STAFF REPORT

SUBJECT: H-2021-0007 – Seasons at Meridian/Winco Wells Subdivision
H-2020-0118 – Volante Investments

LOCATION: 2600 & 2700 E. Overland Rd., in the SE ¼ of Section 17, Township 3N., Range 1E. (Parcels: S1117438626, S1117438451)

A. Preliminary Plat (date: 02/4/2021) & Phasing Plan

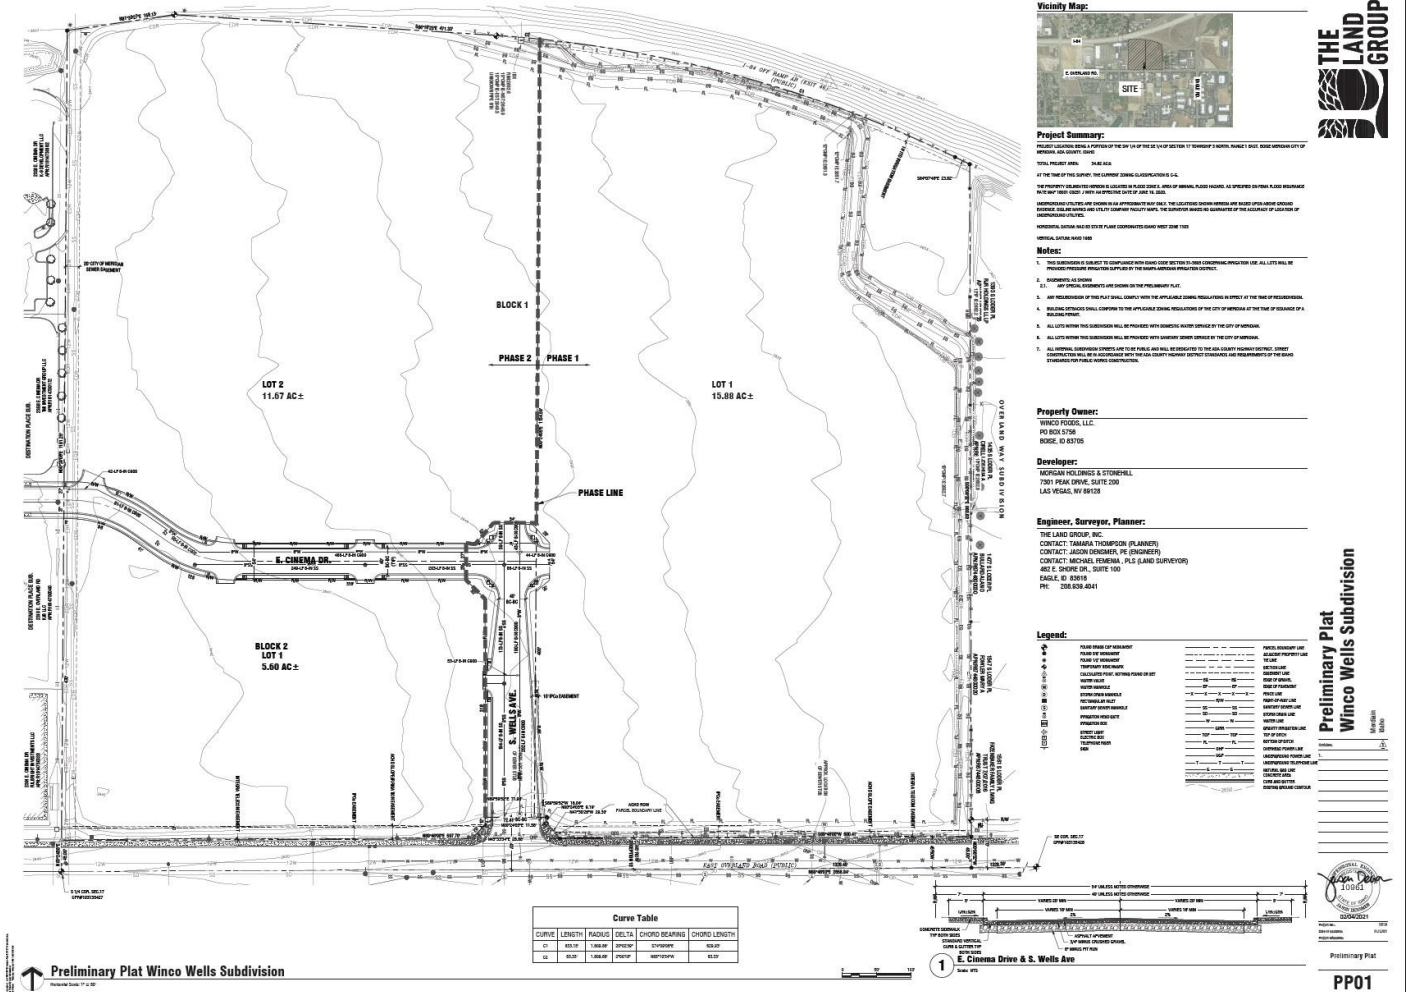
Required street buffer widths are as follows: 25-feet along E. Overland Rd., an arterial street; 10-feet along S. Wells Ave. and E. Cinema Dr., both local streets; and 35-feet along the I-84 off-ramp, an entryway corridor. Street buffer widths are proposed on the landscape plan in accord with these standards. **The plan is missing the street buffer along I-84 on the west parcel (Lot 2, Block 1); the plan should be revised to include this buffer.**

The number of trees proposed in buffers meets the minimum standard; however, a mix of trees and shrubs with lawn or other vegetative groundcover is required – shrubs should be added to the buffers in accord with UDC 11-3B-7C.3a. Street buffers are required to be placed in a common lot or on a permanent dedicated buffer, maintained by the property owner or business owners' association; the plat should be revised accordingly.

3. The final plat shall include the following revisions:
 - a. All street buffers are required to be placed in a common lot or on a permanent dedicated buffer, maintained by the property owner or business owners' association, as set forth in UDC 11-3B-7C.2b.
 - b. Depict the street buffer along E. Overland Rd. outside of the ultimate right-of-way for the widening of Overland to 7-lanes.
 - c. The extension of E. Cinema Dr. shall ~~be included in~~ occur with the first second phase of development.
4. The landscape plan included in Section VIII.B shall be revised as follows:
 - a. Landscaping is required to be provided adjacent to the pathway within the buffer along the I-84 off-ramp per the standards listed in UDC 11-3B-12C. *A mix of trees, shrubs, lawn and/or other vegetative ground cover with a minimum of one (1) tree per 100 linear feet of pathway is required.*

C. Site Plan for Multi-Family Portion of Development (date: 1/14/2020)

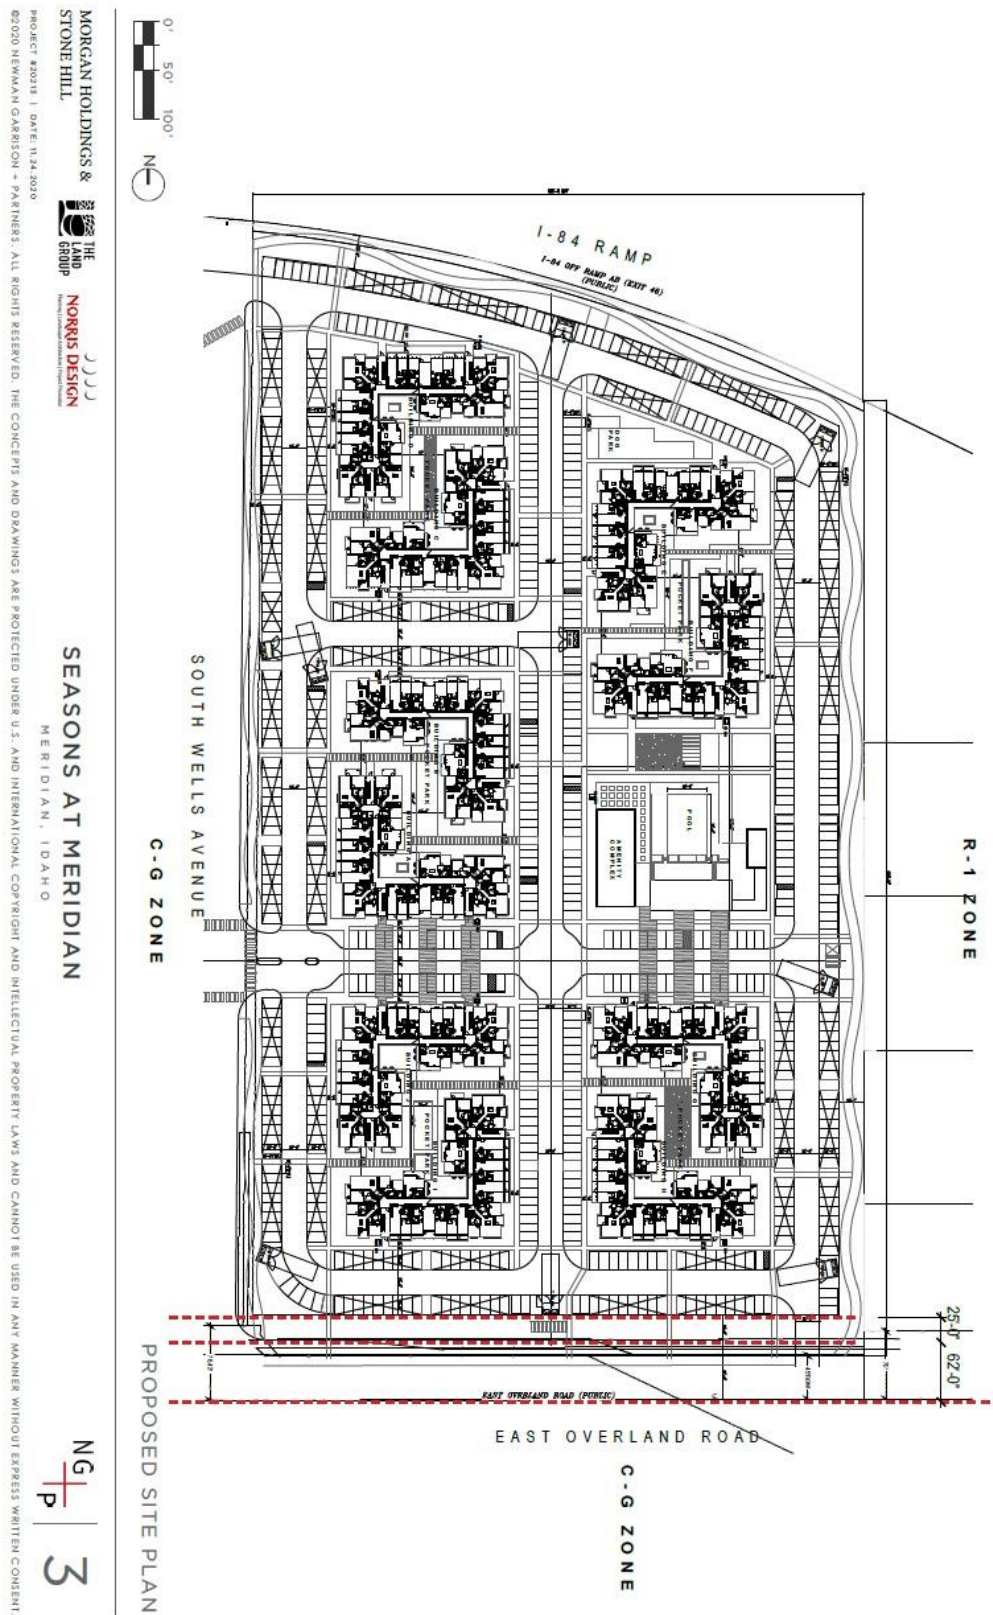
*The Applicant's narrative states these items will be provided; **the site plan submitted with the Certificate of Zoning Compliance application should depict the location of these items in accord with this standard.***

Street buffer landscaping is required to be provided with the subdivision improvements as noted above in Section VI.B. **The site and landscape plans should be revised to include the additional ROW dedication and right-turn lane for Overland Rd.; the street buffer shall be located outside of the ultimate ROW for these improvements.**

- 10. The site and/or landscape plan submitted with the Certificate of Zoning Compliance shall be revised as follows:
 - a. Depict the locations of the property management office, maintenance storage area, central mailbox location (including provisions for parcel mail, that provide safe pedestrian and/or vehicular access), and a directory and map of the development at an entrance or convenient location for those entering the development in accord with UDC 11-4-3-27B.7.
